NextEra Energy Canada, ULC

Addendum to the Project Description Report – Bluewater Wind Energy Centre

March, 2013

Bluewater Wind Energy Centre
Project Modifications Report

Figure 2.1

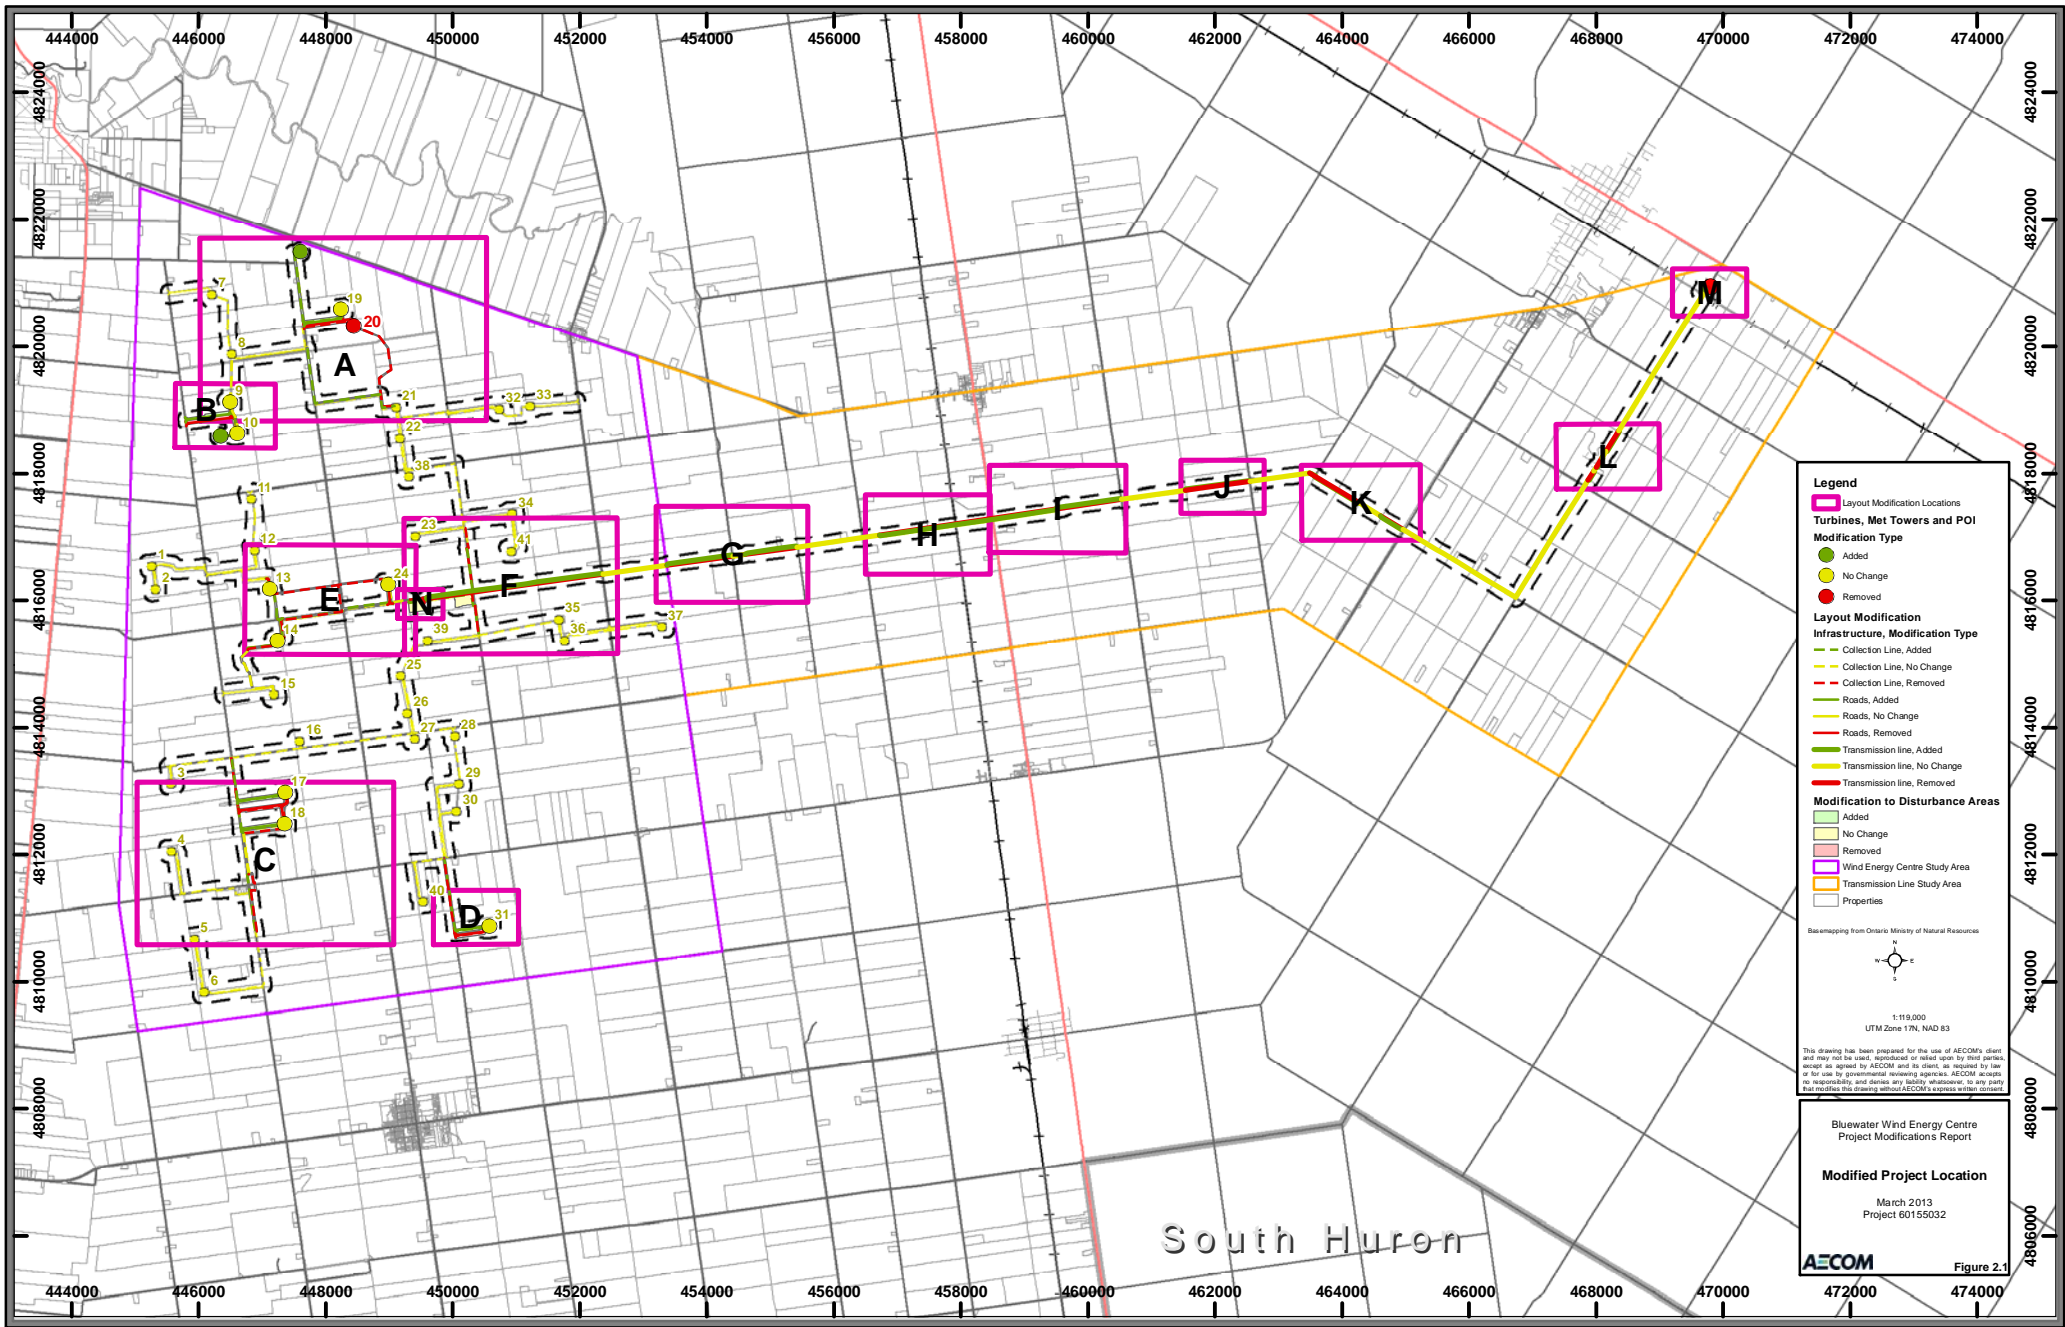
Label on Figure 2-1	Proposed Modification	Rationale for Proposed Modification	New Potential Environmental Effects	New Mitigation Measures
A	A1: Removal of Turbine 20 and associated access road and collection line, and provision of new access road to Turbine 19	Land owner no longer participating in project.	None – no new natural heritage or water body features within 120 m; area previously studied for cultural heritage.	N/A
	A2: Addition of meteorological (met) tower and associated infrastructure on private property	The met tower is required to obtain critical data to ensure the safe and efficient operation of the Project. As per amendment to O.Reg. 359/09, met towers are now considered to be part of a renewable energy generation facility and therefore this tower was added to the assessment.	None – no new natural heritage or water body features within 120 m; area previously studied for cultural heritage.	N/A

A3: Relocation of collection line to Turbine 19 (from Turbine 21) – to travel west on north side of private property and north in the Goshen Line right-of-way	Relocation of the collection line is necessary following the removal of Turbine 20.	Cultural Heritage: • Locations 33 and 34 documented.	Cultural Heritage: • Stage 3 assessment of Locations 33 and 34.
B	B1: Relocation of access road to Turbine 9 – to be relocated to south side of private property – and minor shift to disturbance area associated with Turbine 10	As per land owner request for relocation of access road. Minimize impacts to current land use and agricultural practices.	None – no new natural heritage or water body features within 120 m; area previously studied for cultural heritage.	N/A
	B2: Addition of met tower and associated infrastructure on private property	The met tower is required to obtain critical data to ensure the safe and efficient operation of the Project. As per amendment to O.Reg. 359/09, met towers are now considered to be part of a renewable energy generation facility and therefore this tower was added to the assessment.	None – no new natural heritage or water body features within 120 m; area previously studied for cultural heritage.	N/A

C	C1: Realignment of access road and collection line to Turbine 17 – to travel directly back from Bronson Line	As per land owner request for separate access road. Minimize impacts to current land use and agricultural practices.	None – no new natural heritage or water body features within 120 m; area previously studied for cultural heritage.	N/A
	C2: Addition of crane path between Turbines 17 and 18 (located primarily within footprint of infrastructure that is being removed)	Proposed to reduce cost of construction.	None – no new natural heritage or water body features within 120 m; area previously studied for cultural heritage.	N/A
	C3: Realignment of access road and collection line to Turbine 18 – to travel directly back from Bronson Line	As per land owner request for separate access road. Minimize impacts to current land use and agricultural practices.	Natural Heritage: • Access road proposed within 120 m of natural area 450. Feature previously studied; identified as Significant Woodland (Woodland E) and Generalized Candidate Significant Wildlife Habitat (Amphibian Woodland Breeding Habitat and Habitat for Species of Conservation Concern). Feature treated as Significant Amphibian Woodland Breeding Habitat (AWO-12) with commitment to complete pre-construction evaluation of significance studies. New potential effects associated with access road construction near this feature include: • Accidental intrusion into natural feature resulting in habitat damage; • Disruption of amphibians moving to breeding pools and home range; • Possible indirect effects on breeding pool condition through changes to surface water drainage patterns resulting from access road construction; and • Risk of mortality to amphibians moving between breeding pools and home range due to vehicular collisions along access road	Natural Heritage: • For Amphibian Woodland Breeding Habitat AWO-12 (if determined to be significant), mitigation measures will be the same as described in the approved NHA for other access roads proposed near amphibian woodland breeding habitat features (Section 5.4).

C4: Realignment of collection line at Bronson Line / Kippen Road to follow Bronson Line right of way	Land owner no longer participating in project.	None – no new natural heritage or water body features within 120 m; area previously studied for cultural heritage.	N/A
D	Realignment of access road to Turbine 31 – to travel directly back from Blind Line	As per land owner request for realignment of access road. Minimize impacts to current land use and agricultural practices.	None – no new natural heritage or water body features within 120 m; area previously studied for cultural heritage.	N/A

Label on Figure 2-1	Proposed Modification	Rationale for Proposed Modification	New Potential Environmental Effects	New Mitigation Measures
E	Realignment of collection line between Turbines 13, 14 and 24	Land owner no longer participating in project	<p>Natural Heritage:</p> <ul style="list-style-type: none"> Collection line proposed to be installed beneath natural area 487 via directional drilling. Feature previously studied; identified as Significant Woodland (Woodland K), Candidate Significant Amphibian Woodland Breeding Habitat (AWO-06), and Generalized Candidate Significant Wildlife Habitat (Bat Maternity Colony, Mature Forest Stand, and Habitat for Species of Conservation Concern). New potential environmental effects associated with collection line installation under these features: <ul style="list-style-type: none"> Potential for unplanned intrusion into Significant Woodland Feature K in event of equipment malfunction due to installation of collection line via horizontal directional drilling; and Potential for unplanned intrusion into Significant Amphibian Woodland Breeding Habitat (AWO-06) and Generalized Candidate Significant Wildlife Habitat in natural area 487 in the event of equipment malfunction due to installation of collection line via horizontal directional drilling. 	<p>Natural Heritage:</p> <ul style="list-style-type: none"> For Significant Woodland K, Amphibian Woodland Breeding Habitat AWO-06 (if determined to be significant) and Generalized Candidate Significant Wildlife Habitat in natural area 487, additional mitigation measures included in the EIS that are the same as described in the approved NHA for collection line installation via directional drilling beneath other Significant Woodlands (Section 5.5) and Generalized Candidate Significant Wildlife Habitat (Section 5.3.2.1).

F	F1: Relocation of transmission line from municipal right-of-way onto private property	Landowner has agreed to participate in project.	None – no new natural heritage or water body features within 120 m; area previously studied for cultural heritage.	N/A
	F2: Relocation of transmission line from municipal right-of-way onto private property	Landowner has agreed to participate in project. Avoid conflicts with existing infrastructure in the right-of-way.	<p>Natural Heritage:</p> <ul style="list-style-type: none"> Transmission line is proposed within natural area 514 (vegetation removal required). New site investigation and evaluation of significance studies completed; feature confirmed to be a Significant Woodland (Woodland AJ) and treated as a Significant Bat Maternity Colony (BMC-15) with commitment to complete pre-construction evaluation of significance studies. New potential effects associated with tree removal in these features include: <ul style="list-style-type: none"> Loss of up to 0.1 ha of forest cover in Significant Woodland Feature AJ; Clearing of vegetation for maintenance of the transmission line, resulting in accidental damage to Significant Woodland AJ; Displacement and/or mortality of nursing female and juvenile bats resulting from vegetation clearing for transmission line construction within Bat Maternity Colony BMC-15; Removal of confirmed significant cavity trees or other suitable cavity trees resulting from vegetation clearing for the transmission line within Bat Maternity Colony BMC-15; and Noise disturbance to and/or avoidance behaviour of bats during construction within Bat Maternity Colony BMC-15. 	<p>Natural Heritage:</p> <ul style="list-style-type: none"> Establish an area of forest equal in area to the cleared area through tree planting and management (e.g., in partnership with a local Conservation Authority). Details of the afforestation plan will be provided to MNR in a Compensation Plan. Perform vegetation clearing for construction outside of the breeding bird season and bat maternal period (May 1 to July 31). If this is not possible, MNR will be consulted regarding mitigation measures that may be required. Clearly stake area to be cleared. Fell trees with a chainsaw toward the construction area to reduce damage to adjacent vegetation being retained. Damaged tree roots will be cut clean as soon as possible and exposed roots covered in approved topsoil. This work to be carried out under supervision of an Arborist or Forester. Prepare a tree preservation plan which identifies specific trees to be removed and whether each tree contains a cavity suitable for potential use as a bat maternity colony. For each suitable cavity tree to be removed, a bat house will be installed in the closest suitable woodland habitat (the remainder of the woodland for the affected habitat). Details will be determined through consultation with MNR. Tree removal will occur during daylight hours. Schedule vegetation clearing for operational maintenance to occur outside of the breeding bird season (May 1 to July 31). Undertake active nest surveys if vegetation removal must take place during this period.

F3: Relocation of transmission line from municipal right-of-way onto private property	Landowner has agreed to participate in project. Avoid conflicts with existing infrastructure in the right-of-way.	None – no new natural heritage or water body features within 120 m; area previously studied for cultural heritage.	N/A

Label on Figure 2-1	Proposed Modification	Rationale for Proposed Modification	New Potential Environmental Effects	New Mitigation Measures
G	G1: Relocation of transmission line from municipal right-of-way onto private property	Landowner has agreed to participate in project. Avoid conflicts with existing infrastructure in the right-of-way.	None – no new natural heritage or water body features within 120 m; area previously studied for cultural heritage.	N/A
	G2: Relocation of transmission line from municipal right-of-way onto private property	Landowner has agreed to participate in project. Avoid conflicts with existing infrastructure in the right-of-way.	Water Bodies: • No effects provided that transmission poles are set back 10-15 m from top of bank.	N/A
	G3: Relocation of transmission line from municipal right-of-way onto private property	Landowner has agreed to participate in project. Avoid conflicts with existing infrastructure in the right-of-way.	None – no new natural heritage or water body features within 120 m; area previously studied for cultural heritage.	N/A

H	Relocation of transmission line from municipal right-of-way onto private property	Landowner has agreed to participate in project. Avoid conflicts with existing infrastructure in the right-of-way.	None – no new natural heritage or water body features within 120 m; area previously studied for cultural heritage.	N/A
I	I1: Relocation of transmission line from municipal right-of-way onto private property	Landowner has agreed to participate in project. Avoid conflicts with existing infrastructure in the right-of-way.	Natural Heritage: • None – no new natural heritage features within 120 m. Water Bodies: • No effects provided that transmission poles are set back 10-15 m from top of bank.	N/A
	I2: Relocation of transmission line from municipal right-of-way onto private property	Landowner has agreed to participate in project. Avoid conflicts with existing infrastructure in the right-of-way.	Natural Heritage: • Transmission line is proposed within natural area 551 (vegetation removal required). New site investigation and evaluation of significance studies completed; feature confirmed to be a Significant Woodland (Woodland AO) and Habitat for Bird Species of Conservation Concern (Red-Headed Woodpecker) (SCB-02). New potential effects associated with tree removal in these features include: • Loss of up to 0.2 ha of forest cover in Significant Woodland Feature AO; • Clearing of vegetation for maintenance of the transmission line, resulting in accidental damage to Significant Woodland AO; • Removal of vegetation (up to 0.1 ha) within significant feature resulting in habitat damage from clearing for transmission line in Red-headed Woodpecker Habitat Feature SCB-02; • Red-Headed Woodpecker Breeding Habitat Feature (SCB-02) may be disturbed by routine maintenance of the transmission line corridor; and • Noise disturbance to breeding Red-headed Woodpeckers during transmission line construction within Red-headed Woodpecker Habitat Feature SCB-02. Water Bodies: • No effects provided that transmission poles are set back 10-15 m from top of bank.	Natural Heritage: • Establish an area of forest equal in area to the cleared area through tree planting and management (e.g., in partnership with a local Conservation Authority). Details of the afforestation plan will be provided to MNR in a Compensation Plan. • Perform vegetation clearing for construction outside of the breeding bird season (May 1 to July 31). If this is not possible: • maintain a 20 m buffer around any active Red-headed Woodpecker nest within which no vegetation removal will occur; and • MNR will be consulted regarding mitigation measures that may be required. • Clearly stake area to be cleared. • Fell trees with a chainsaw toward the construction area to reduce damage to adjacent vegetation being retained. • Damaged tree roots will be cut clean as soon as possible and exposed roots covered in approved topsoil. This work to be carried out under supervision of an Arborist or Forester. • Minimize the area of tree removal within the natural area to the extent possible. • Remove trees by hand-held equipment and drag them out of the natural area to minimize soil disturbance. If possible, leave some woody debris to decompose naturally. • Any vehicles used within the natural area will have wide-based tires. Tracked vehicles will be avoided. • Schedule vegetation clearing for operational maintenance to occur outside of the breeding bird season (May 1 to July 31). If vegetation clearing takes place during this timing window, nest searches will be conducted by qualified Biologist.

J	J1: Relocation of transmission line from municipal right-of-way onto private property	Landowner has agreed to participate in project. Avoid conflicts with existing infrastructure in the right-of-way.	Natural Heritage: • Transmission line is proposed within natural area 555. New site investigation and evaluation of significance studies completed; feature confirmed to be a Significant Woodland (Woodland AP). New potential effects associated with tree removal in this feature include: • Loss of up to 0.2 ha of forest cover in Significant Woodland Feature AP; and • Clearing of vegetation for maintenance of the transmission line, resulting in accidental damage to Significant Woodland AP. Cultural Heritage: • Location 29 documented.	Natural Heritage: • Establish an area of forest equal in area to the cleared area through tree planting and management (e.g., in partnership with a local Conservation Authority). Details of the afforestation plan will be provided to MNR in a Compensation Plan. • Perform vegetation clearing for construction outside of the breeding bird season (May 1 to July 31). If this is not possible, MNR will be consulted regarding mitigation measures that may be required. • Clearly stake area to be cleared. • Fell trees with a chainsaw toward the construction area to reduce damage to adjacent vegetation being retained. • Damaged tree roots will be cut clean as soon as possible and exposed roots covered in approved topsoil. This work to be carried out under supervision of an Arborist or Forester. • Schedule vegetation clearing for operational maintenance to occur outside of the breeding bird season (May 1 to July 31). Undertake active nest surveys if vegetation removal must take place during this period. Cultural Heritage: • Stage 3 assessment of Location 29.

J2: Relocation of transmission line from municipal right-of-way to follow unopened municipal right-of-way	Avoid conflicts with existing infrastructure in the right-of-way.	Natural Heritage: • Transmission line is proposed within natural area 582. New site investigation and evaluation of significance studies completed; not a significant feature. Water Bodies: • No effects provided that transmission poles are set back 10-15 m from top of bank.	Natural Heritage: • N/A

Label on Figure 2-1	Proposed Modification	Rationale for Proposed Modification	New Potential Environmental Effects	New Mitigation Measures
K	K1: Relocation of transmission line from municipal right-of-way onto private property	Landowner has agreed to participate in project. Avoid conflicts with existing infrastructure in the right-of-way.	None – no new natural heritage or water body features within 120 m. Area subsequently studied for cultural heritage – no new resources affected.	N/A
	K2: Relocation of transmission line from municipal right-of-way onto private property	Landowner has agreed to participate in project. Avoid conflicts with existing infrastructure in the right-of-way.	Water Bodies: • No effects provided that transmission poles are set back 10-15 m from top of bank.	N/A
	K3: Relocation of transmission line from municipal right-of-way onto private property	Landowner has agreed to participate in project. Avoid conflicts with existing infrastructure in the right-of-way.	None – no new natural heritage or water body features within 120 m; area previously studied for cultural heritage.	N/A

L	Relocation of transmission line from municipal right-of-way onto private property	Landowner has agreed to participate in project. Avoid conflicts with existing infrastructure in the right-of-way.	Water Bodies: • No effects provided that transmission poles are set back 10-15 m from top of bank.	N/A
M	Relocation of Point of Interconnect (POI) from Seaforth substation property to private property	Land owner agreed to participate in the project Avoid conflicts with existing infrastructure.	None – no new natural heritage or water body features within 120 m; area previously studied for cultural heritage.	N/A
N	Relocation of substation within the same property parcel	Original location was in a floodplain.	None – no new natural heritage or water body features within 120 m; area previously studied for cultural heritage.	N/A
